### **ITEM # 3.0**

#### **PRELIMINARY & FINAL PLAT APPROVAL:**

Bellwood Manor Subdivision  
A tract of land containing 26.79 acres of land  
being part or portion of Lot 39, Lot 40, Lot 41, and  
a 70.00' strip of canal Right-of-Way between Lot 40  
and Lot 41, Bell-Woods Company's Subdivision "C"  
R-2  
Developer: DS3 Development, LLC  
Engineer: S2 Engineering, PLLC

### **REVIEW DATA**

# WATER LAYOUT OF: BELLWOOD MANOR

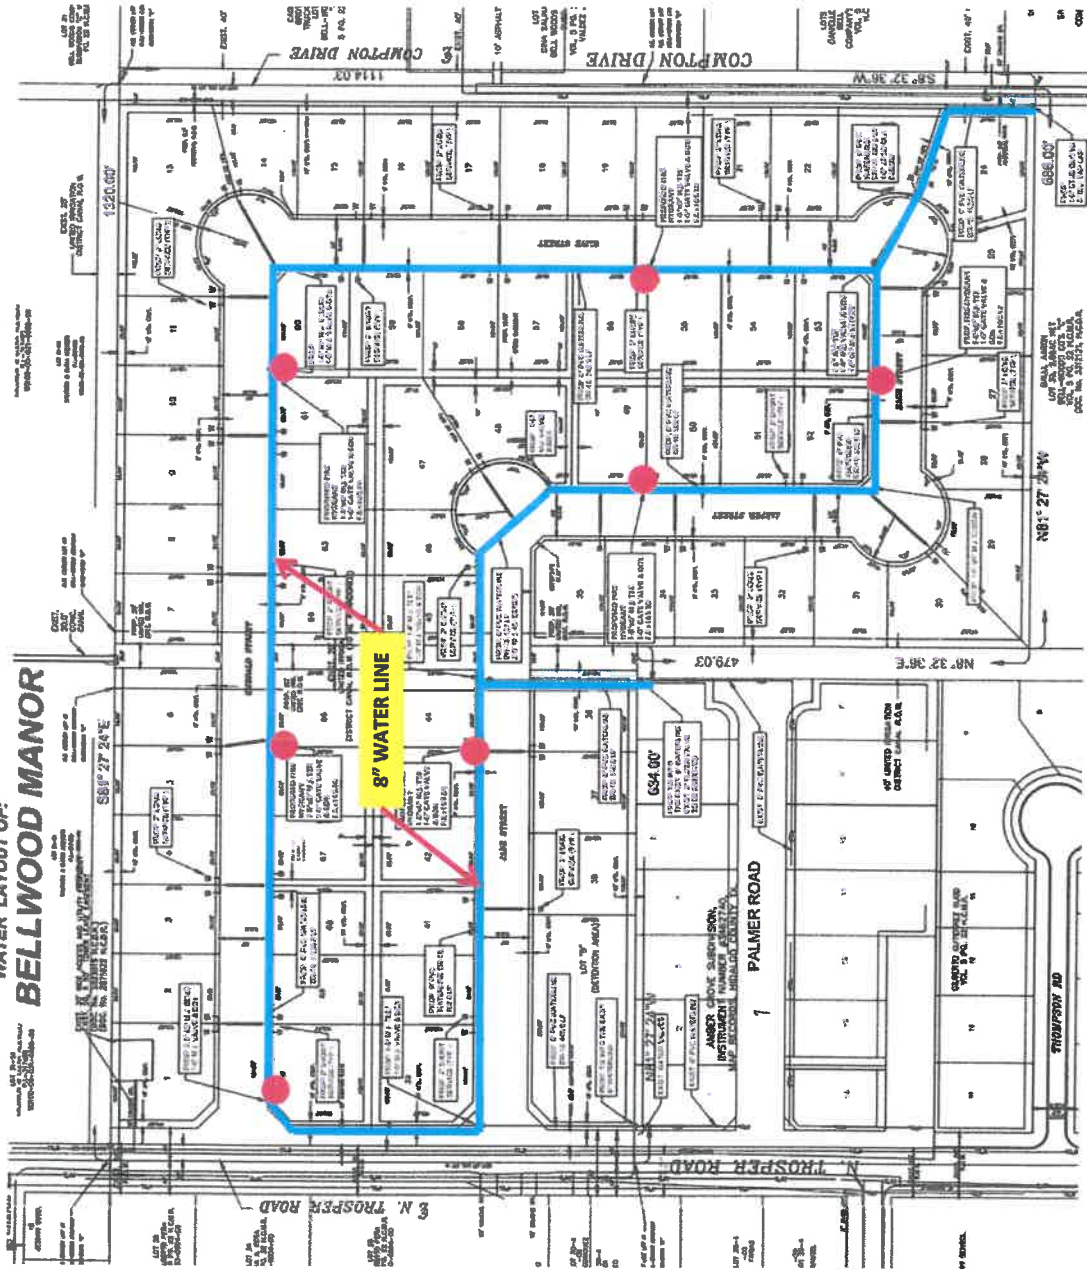
The developer is proposing to connect from an existing 8" water line located along the east side of N. Trospen Road and looped with a proposed 8" water line to the water system of Amber Groves Estates Subdivision which is prepped with a flush valve that will be removed. Each lot will be serviced by a 2" water line to accommodate each duplex-fourplex. They are proposing 7 fire hydrants as via direction of the Fire Marshal's office. — **see utility plan**

**SANITARY SEWER LAYOUT OF:  
BELLWOOD MANOR**

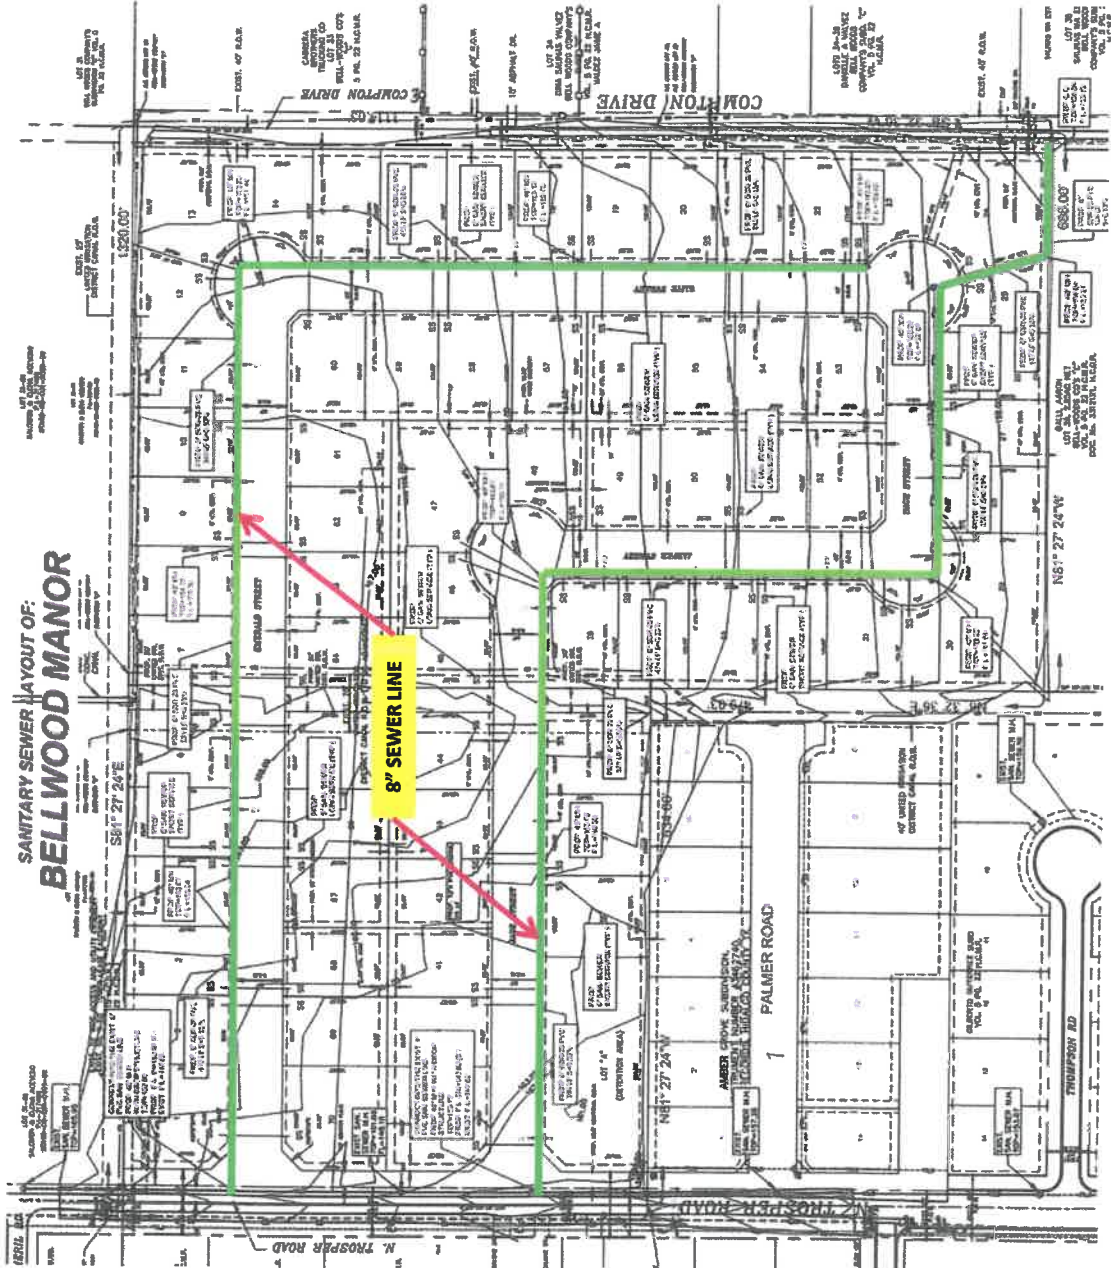
Wastewater service will connect to an existing 8" PVC sanitary sewer line by a proposed MH with a drop structure along the East side N. Trospen Rd. ROW at 2 different locations. An internal 8" sewer line system will provide 6" sewer service to all the lots. The Capital Sewer Recovery Fee is required at \$670.00/Lot which equates to \$46,900.00 (\$670.00 x 70 lots).
